Technical information

Date: 29.08.02
No.: 01/02

Subject:
HOT GAS DEFROST, TEMPERATURE PROBE

Models:
STARFOOD

Fig. 1

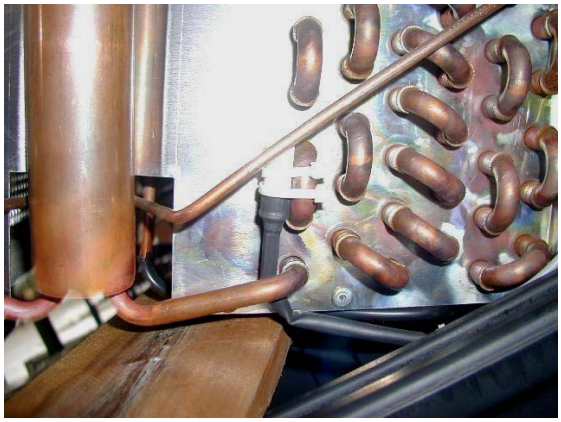
Due to oxidation problems on probe connections noticed on several Starfood cooling units, after some tests, we were be able to observe that it was caused by condensation on hot gas probe connections between the insulating sheath and the probe wiring (Fig. 1).

Due to the condensation water on the terminals, the machine sees the probe as being short circuit and therefore displays the message above.

To avoid the problem, probes have been positioned the evaporator in a different way and also, the sheaths have been lengthened.

Therefore, if some cooling unit should have this kind of problem, we suggest replacing and repositioning the hot gas probe, as shown in Fig. 2.

The part number for the replacement probe is 986060
